Access Compliance Report

Public Rights-of-Way

(Curb Ramps)

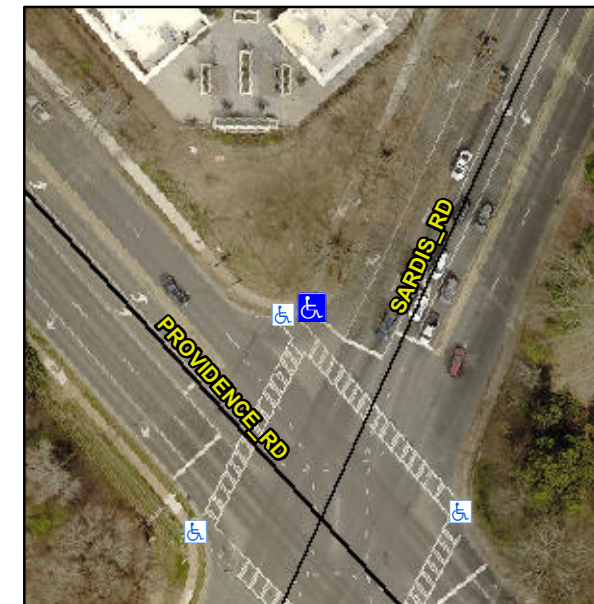
Intersection ID: 19925	Main Street: SARDIS_RD	Cross Street: PROVIDENCE_RD	Location: NE
ADA ID: 51FEE5993931	Ramp Type: Perp	Initial Pass/Fail: Fail	Overall Compliance: No
Severity Score: 13.75			
Codes/Mitigation Info/Possible Solution		Field Measurements/Component Compliance

Not Found, R304.2.2, R304.5.3

Compliance	Description	Data	Compliance	Description	Data
N/A	Ramp Length (in)	48.0	No	Ramp Slope (%)	9.1
Yes	Ramp Width (in)	48.0	No	Ramp XSlope (%)	2.7
N/A	Flare Type LT	N/A	N/A	Flare Type RT	N/A
N/A	Flare Slope LT (%)	N/A	N/A	Flare Slope RT (%)	N/A
N/A	Flare Traversable LT?	N/A	N/A	Flare Traversable RT?	N/A
N/A	Landing Length (in)	N/A	N/A	DWS Provided?	N/A
N/A	Landing Width (in)	N/A	N/A	DWS Contrast?	N/A
N/A	Landing Slope (%)	N/A	N/A	DWS Length (in)	N/A
N/A	Landing X Slope (%)	N/A	N/A	DWS Full Width?	N/A
N/A	Landing Curb? (Y/N)	N/A	N/A	DWS Offset (in)	N/A
N/A	Shared Landing?	N/A			
N/A	Gutter Ponding?	N/A	N/A	Gutter Slope (%)	N/A
N/A	Gutter Lip Ht (in)	N/A	N/A	Gutter X Slope (%)	N/A
N/A	Painted X Walk1?	Yes	N/A	Painted X Walk2?	N/A
	X Walk 1 Direction	To SE		X Walk 2 Direction	N/A
N/A	X Walk 1 Width (in)	104.0	N/A	X Walk 2 Width (in)	N/A
	X Walk 1 Slope (%)	0.4		X Walk 2 Slope (%)	N/A
	X Walk 1 X Slope (%)	0.5		X Walk 2 X Slope (%)	N/A

Remove & Replace Entire Ramp.
